Contract #: 04-0120F4Cty: SF/ALA Rte: 80 PM: 13.2/13.9File #: 69.25B**QUALITY ASSURANCE -- NON-CONFORMANCE REPORT****Location:** Changxing Island, Shanghai, P.R. China**Report No:** NCR-000633**Prime Contractor:** American Bridge/Fluor Enterprises, a JV**Date:** 14-Jan-2010**Submitting Contractor:** Zhenhua Port Machinery Company, Ltd (ZPMC), Changxing Island**NCR #:** ZPMC-0606**Type of problem:****Welding****Concrete****Other****Welding****Curing****Procedural****Bridge No:** 34-0006**Joint fit-up****Coating****Other****Component:** 6BW-6CW Side and Bottom Panel T-Rib and I-Rib**Procedural****Procedural****Description:**

Reference Description: 6BW to 6CW Stiffener to Stiffener weld joints were welded with offset exceeding 3mm

Subject: NCR No. ZPMC-0606

Job Name: SAS Superstructure

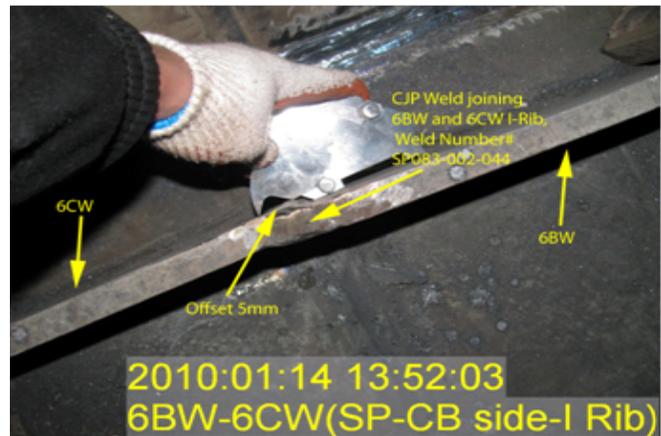
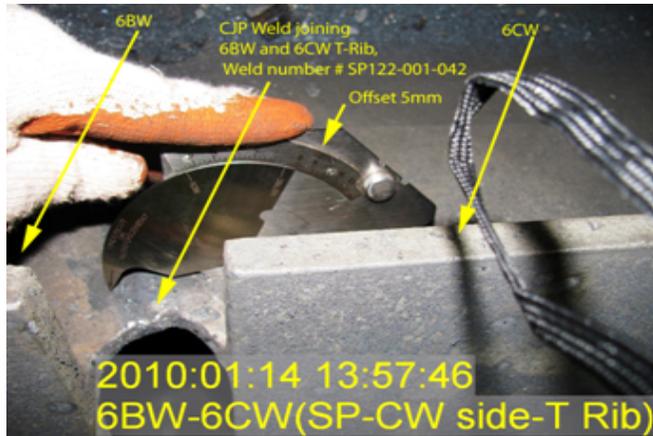
-Two (2) T-Rib web welds and One (1) I-Rib weld between the 6BW to 6CW (transverse splice) were misaligned across the weld joints.

- 1) SP083-002-044 (1st I-Rib on SP from top-CB side)
- 2) BP087-001-030 (6th T-Rib on BP from work point W3)
- 3) SP122-001-042 (7th T-Rib on SP from bottom-CW side)

-The out of tolerance offset measurement across the welds were measured at 5mm.

-The maximum out of tolerance allowed per AWS D1.5 2002 is 3mm.

ZPMC cut off the ribs and re-welded them to rectify the misalignment issue. The alignment is now acceptable and has been removed from the punchlist to show that the alignment is acceptable. ZPMC is providing the repair report used to correct the misalignment as well as the NDT after to show the cut welds are acceptable. Based on this ZPMC requests that this NCR be closed.

This proposed resolution is acceptable. The documentation received is sufficient and the Department concurs that Non-Conformance ZPMC-0606 is closed.

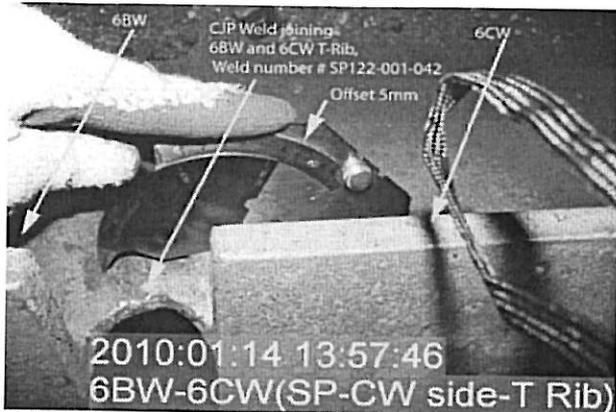
-Two (2) T-Rib web welds and One (1) I-Rib weld between the 6BW to 6CW (transverse splice) were misaligned across the weld joints.

- 1) SP083-002-044 (1st I-Rib on SP from top-CB side)
- 2) BP087-001-030 (6th T-Rib on BP from work point W3)
- 3) SP122-001-042 (7th T-Rib on SP from bottom-CW side)

-The out of tolerance offset measurement across the welds were measured at 5mm.

-The maximum out of tolerance allowed per AWS D1.5 2002 is 3mm.

Remove weld to correct fit-up issue, reweld and perform NDT required to verify weld quality.

Welds were removed and members were brought with in Contract fit-up tolerance and NDT documentation was submitted verifying the welds are in conformance with Contract specifications. An internal NCR was also issued by the Contractor in regards to this issue.

Draft of welding discontinuity:

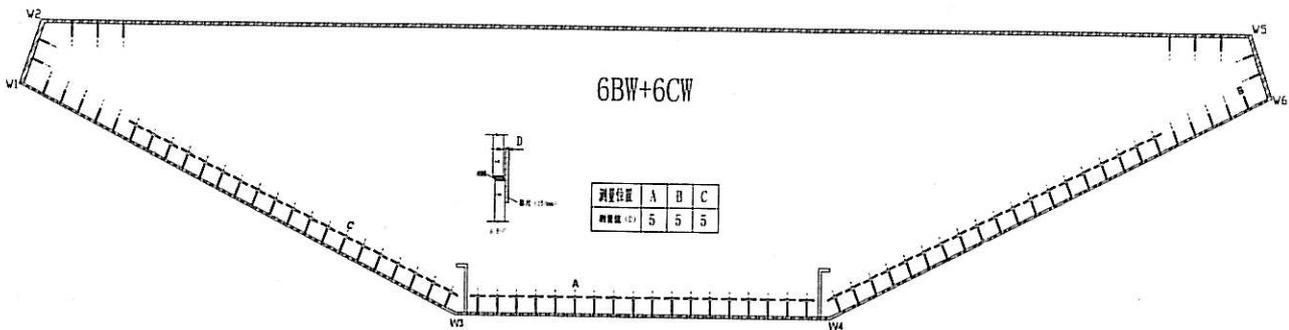
After inspection: I-ribs and T-ribs were misalignment at 6BW and 6CW, the detail position sees the following draft, weld ID: SP083-001-044, BP087-001-030, SP122-001-042

1. Remove the welds between I-Ribs/T-Ribs, I-Ribs/T-Ribs and BP/SP at the splice by grinding or cutting. The weld length to be removed will be determined by actual situation. Preheat according to the WPS prior to gouging.
2. Adjust the misalignment of T-Ribs/I-Ribs to meet the tolerance. The transition is not more than 1:10.
3. Prepare the excavation according to the relevant WPS.
4. Preheat and weld according to the WPS.
5. Grind the weld flush to the adjacent weld or base metal.
6. Check the welds according to the shop drawings.
